**STAFF RECOMMENDATION**  
**2008 Cedar Lane**  
**February 21, 2018**

**Application:** New construction—Infill and outbuilding; setback determination  
**District:** Belmont-Hillsboro Neighborhood Conservation Zoning Overlay  
**Council District:** 18  
**Map and Parcel Number:** 117030039  
**Applicant:** William Smallman  
**Project Lead:** Jenny Warren, jenny.warren@nashville.gov

<p><b>Description of Project:</b> Application is for the construction of a new single family house and an outbuilding, with a side setback determination.</p> <p><b>Recommendation Summary:</b> Staff recommends disapproval of the proposed infill and outbuilding finding that the primary dwelling does not meet sections II.B.a, b, and c for height, scale and rhythm of spacing and the outbuilding does not meet section II.B.i.2 for appropriate location and setbacks and section 17.16.30.G. 4 of the ordinance.</p> <p>Staff finds that the project does not meet Sections II.B. of the <i>Belmont-Hillsboro Neighborhood Conservation Zoning Overlay: Handbook and Design Guidelines</i>.</p>	<p><b>Attachments</b> <b>A:</b> Photographs <b>B:</b> Site Plan <b>C:</b> Elevations</p>
---	--

DETACHED GARAGE

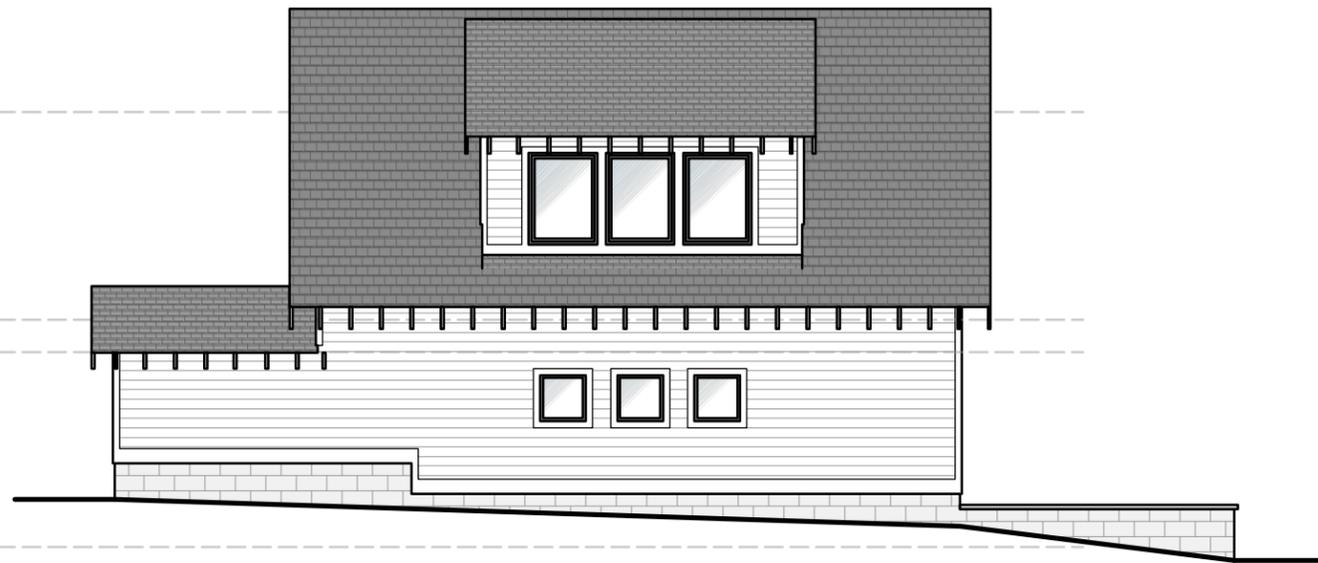
Outbuilding description:	Square footage	Minimum Rear/Alley Setback	Minimum Side Setback for interior lot lines	Distance Between Principal Building and Outbuilding
Footprint more than 700 sq. ft., Garage doors do not face alley, interior lot	750 sq ft	3’	5’	20’
Proposed	749 sq ft	~180’	3’1” on west 36’10” on east	9’

The new outbuilding does not require a rear setback determination as it is sited more than one hundred and eighty feet (180') from the rear property line. It does require a side setback determination as the garage is sited only three feet one inch (3'1") from the side property line. Further, the outbuilding is not separated from the main house by twenty feet (20'), as required by the guidelines. The applicant has proposed to site the garage to the side of the covered rear patio, nine feet (9') from the corner of the house. The garage will be attached to the patio with a covered breezeway. The Commission has allowed outbuildings to be closer than twenty feet (20') to houses in cases where there are site constraints. However, this property stretches three hundred and ninety-two feet (392') deep, allowing plenty of space for both the twenty foot (20') separation, and the five foot side setback.

The project does not meet section II.B.i.2 of the design guidelines and 17.16.30.G. 4 of the ordinance.

Staff finds that the proposed outbuilding meets Section II.B.1.i of the design guidelines in terms of design, but does not meet the guidelines in terms of side setback and distance from the outbuilding to the main house.
